December 4, 2019

Beth Rudolph, PE
Town Engineer
Engineering Department
71 Mount Vernon Street
Winchester, MA 01890

Re: **Water and Sewer System Peer Review for Proposed 147-Unit Apartment Building at 19-35 River Street by SLV River Street, LLC**

FIGURE 1
SEWER INVESTIGATION SUMMARY

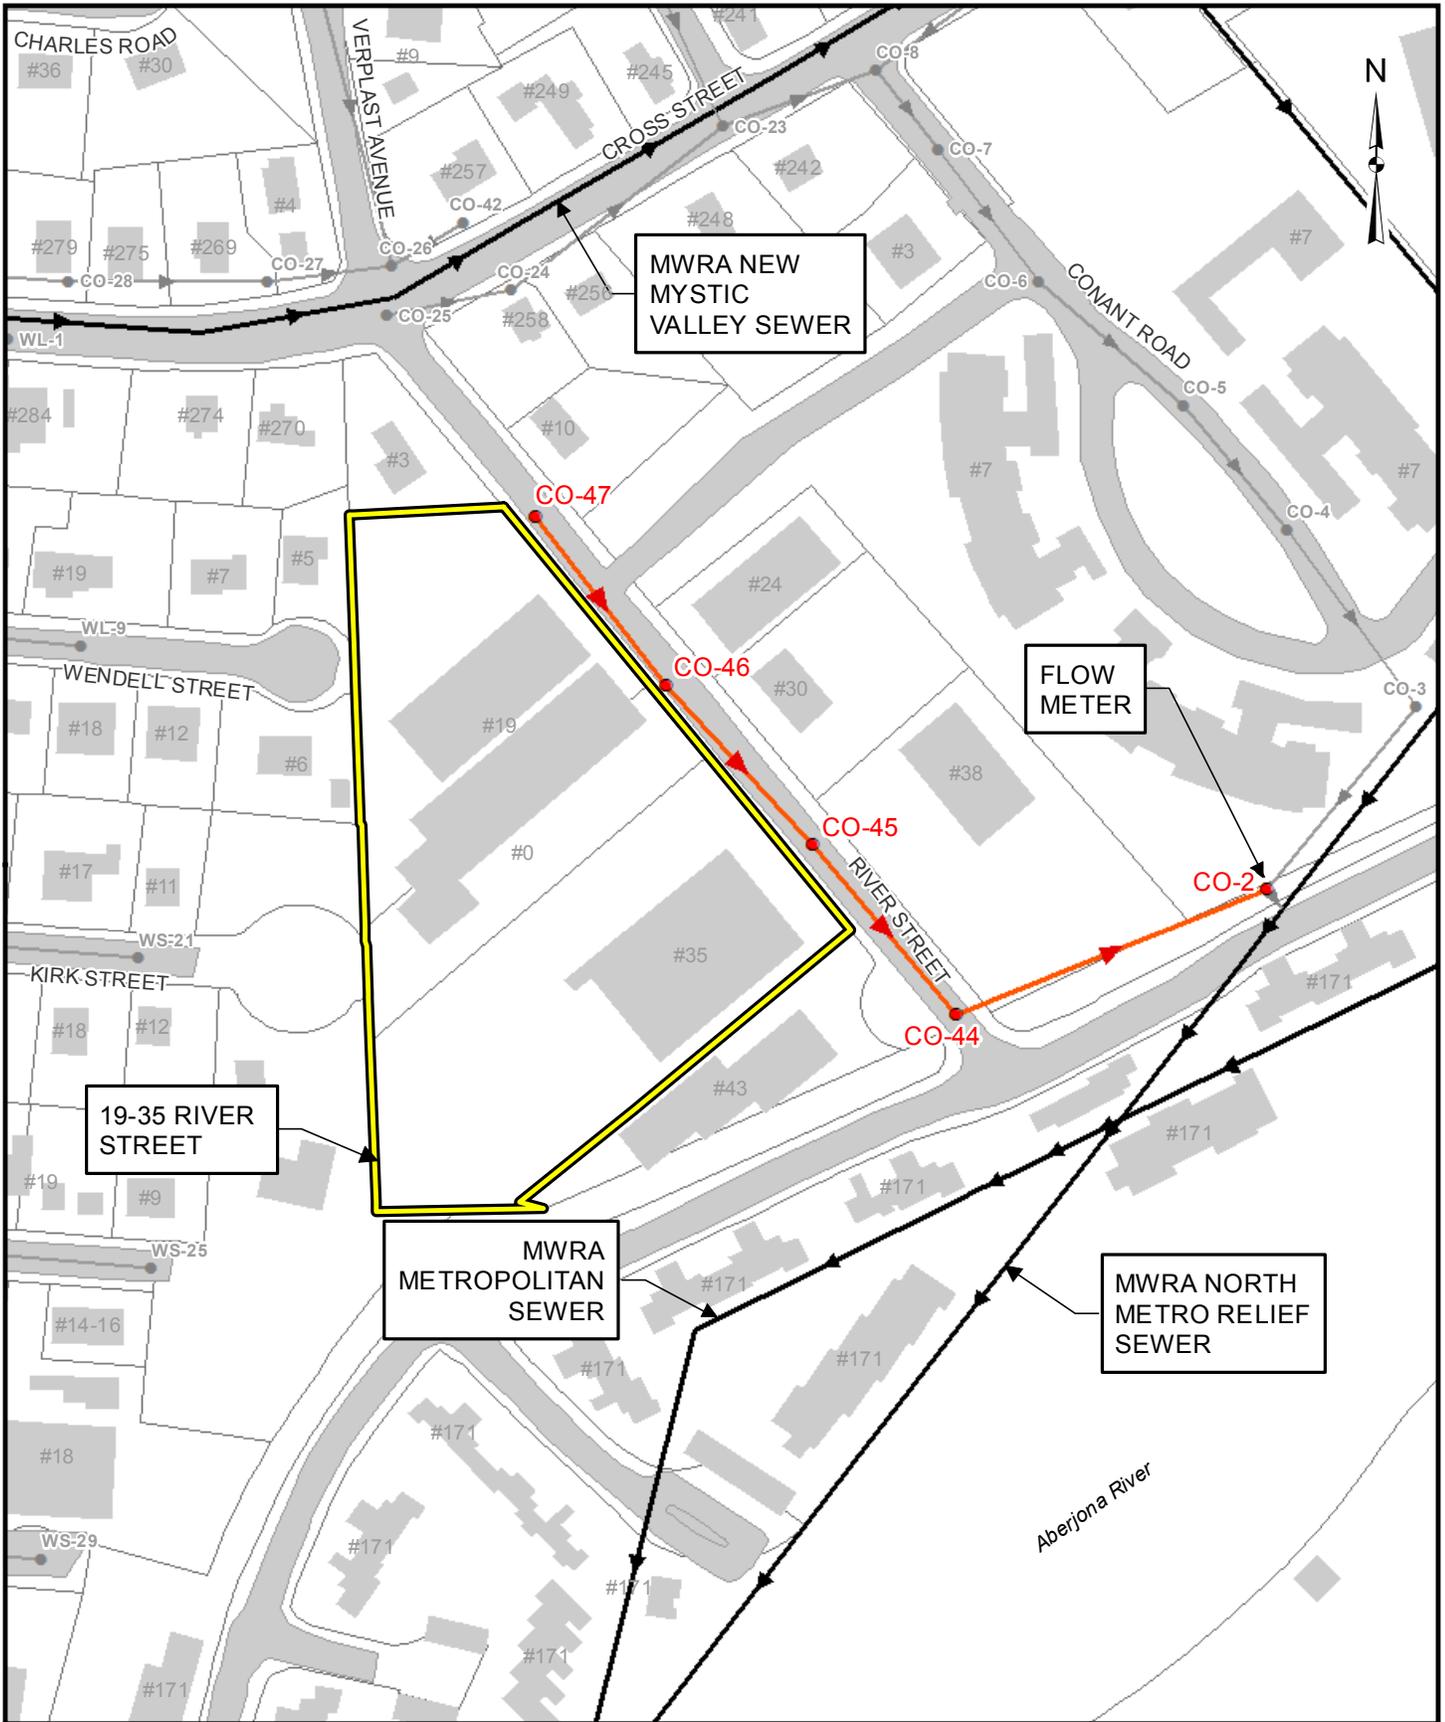
Weston & Sampson evaluated the existing sewer infrastructure on River Street between the upstream manhole (CO-47) and the downstream manhole (CO-2) where it discharges into the MWRA collection system. As part of the evaluation, Weston & Sampson performed a hydraulic capacity analysis (Appendix A), reviewed pipe inspection data provided by the town, and performed sewer manhole inspections between CO-47 and CO-2. A locus map of the sewer system investigation is included as Figure 1.

Weston & Sampson reviewed sewer pipe inspection video provided by the town and performed manhole inspections on River Street and Conant Road ROW. The River Street/Conant Road ROW sewer system consists of approximately 814 linear feet of 8-inch asbestos cement pipe and five (5) block sewer manholes.

Our review of the pipe inspection video identified three (3) active services in the direction of 19-35 River Street, which will be disconnected once the existing buildings are demolished. We recommend abandoning these services at the mainline by plugging them with grout and installing a cured-in-place short liner over the service connection. The inspection also identified two (2) active services with infiltration staining at the break-in pipe connection. We recommend installing lateral liners at these locations.

TV inspection of CO-44 to CO-2 identified moderate debris along the invert of the pipe from station 1+50 to station 2+80. Complete TV inspection of this pipe segment was obtained; however, we recommend performing additional cleaning in this pipe segment.

Our review of the manhole inspection data identified two (2) manholes with active infiltration and four (4) manholes with root intrusion. Weston & Sampson recommends performing root treatment at CO-44 and CO-47 and cementitious lining at CO-2, CO-44, and CO-47. Manholes CO-45 and CO-46 are recommended to be replaced with precast manholes as discussed above.

RECOMMENDED SEWER SYSTEM REHABILITATIONS

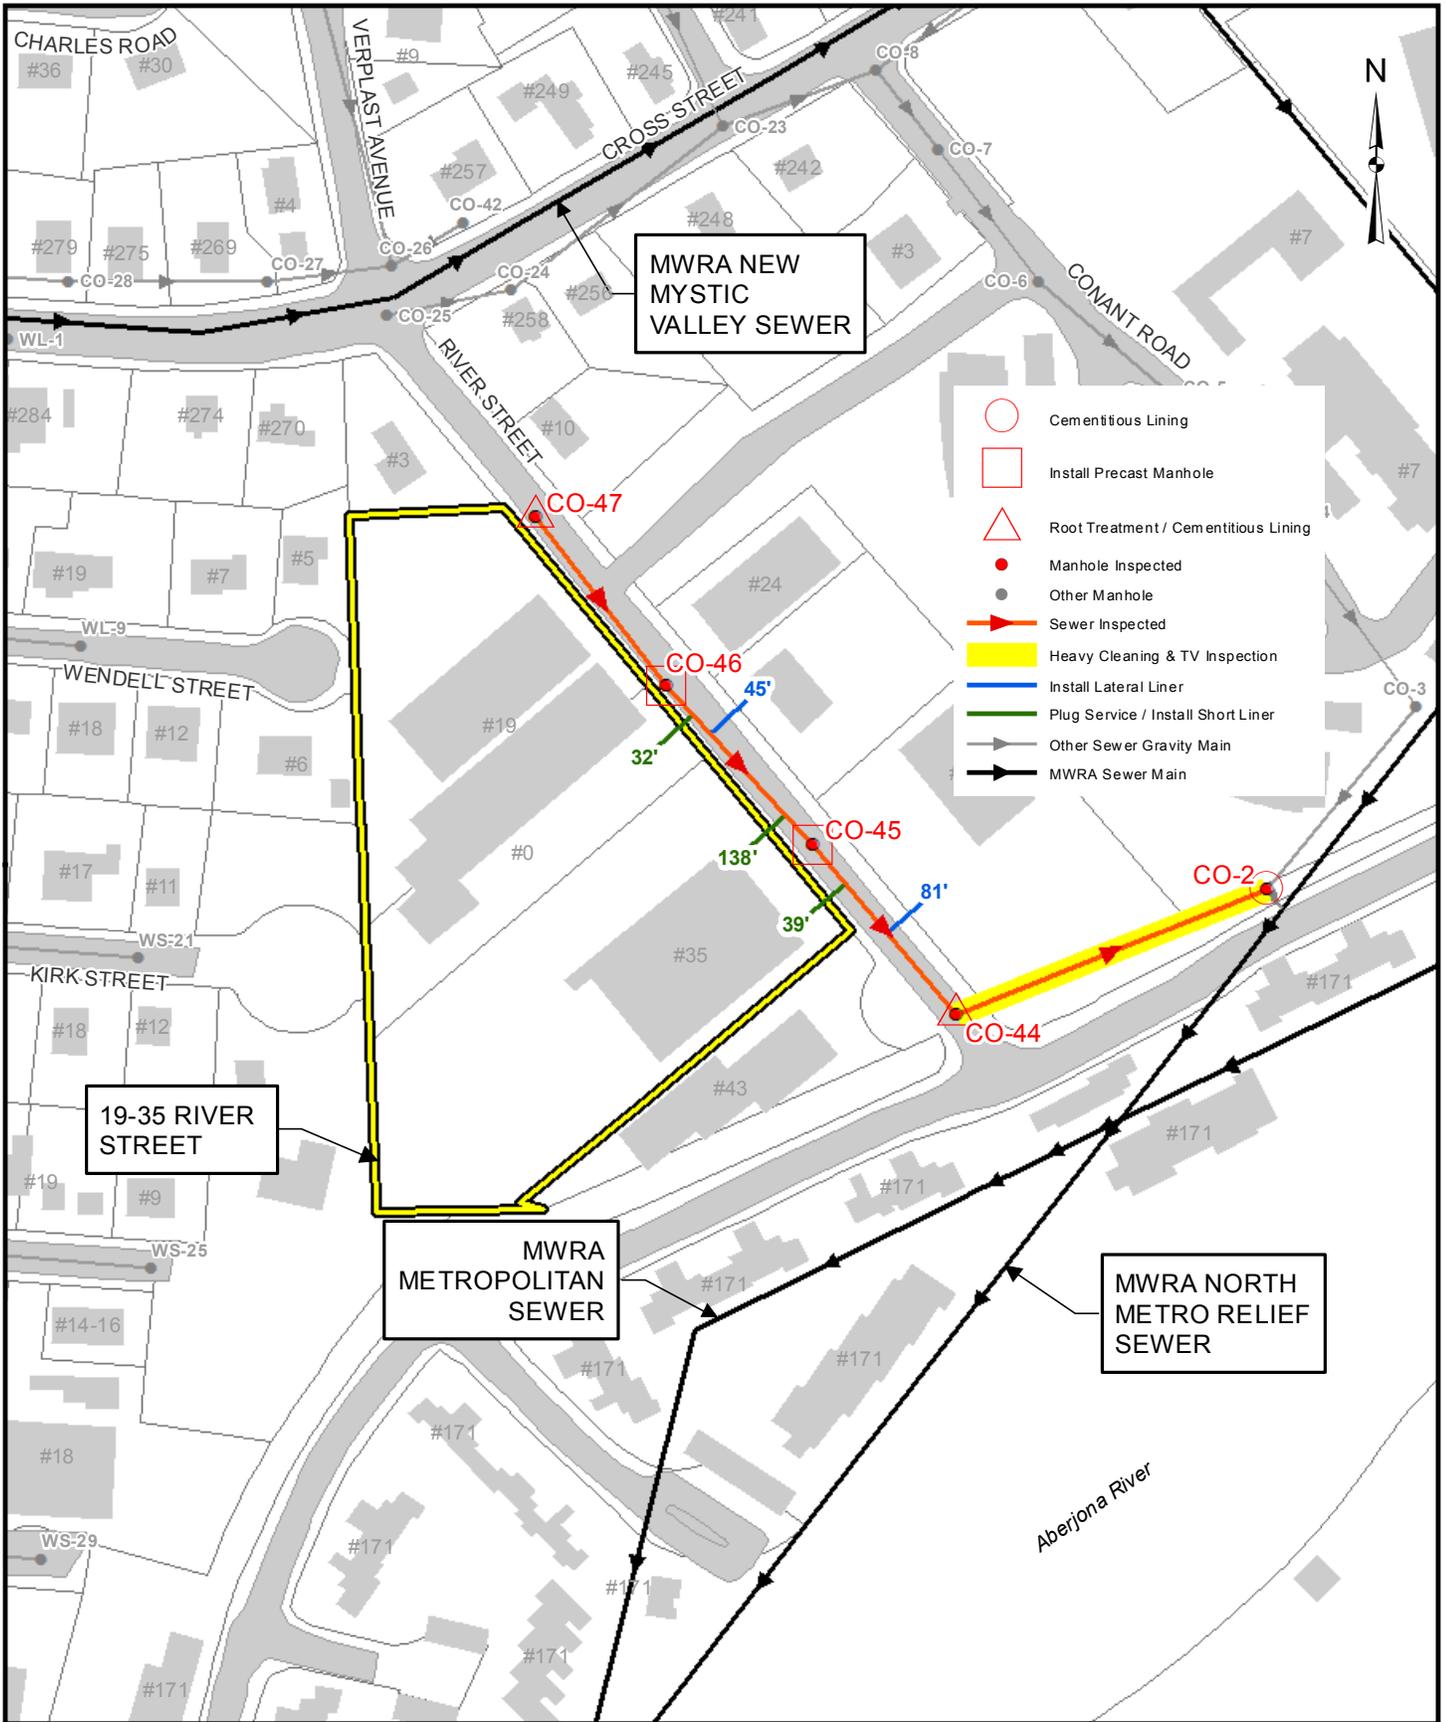
Weston & Sampson recommends the following sewer rehabilitations:

- Install two (2) lateral liners
- Abandon existing sewer services at 19-35 River Street. Plug service with grout and install cured-in-place short liner; three (3) services, 12 linear feet of short liners
- Perform manhole chemical root treatment at CO-44 and CO-47
- Perform grouting and cementitious lining of manholes at CO-2, CO-44, and CO-47; 23.7 vertical feet
- Install new precast manholes at CO-45 and CO-46 for building service connection and gas/oil separation connection; 12.1 vertical feet
- Perform heavy cleaning and television inspection, CO-44 to CO-2, 290 linear feet

The estimated cost of these sewer rehabilitations is \$63,888. The proposed sanitary sewer rehabilitations are indicated on the map included as Figure 2.
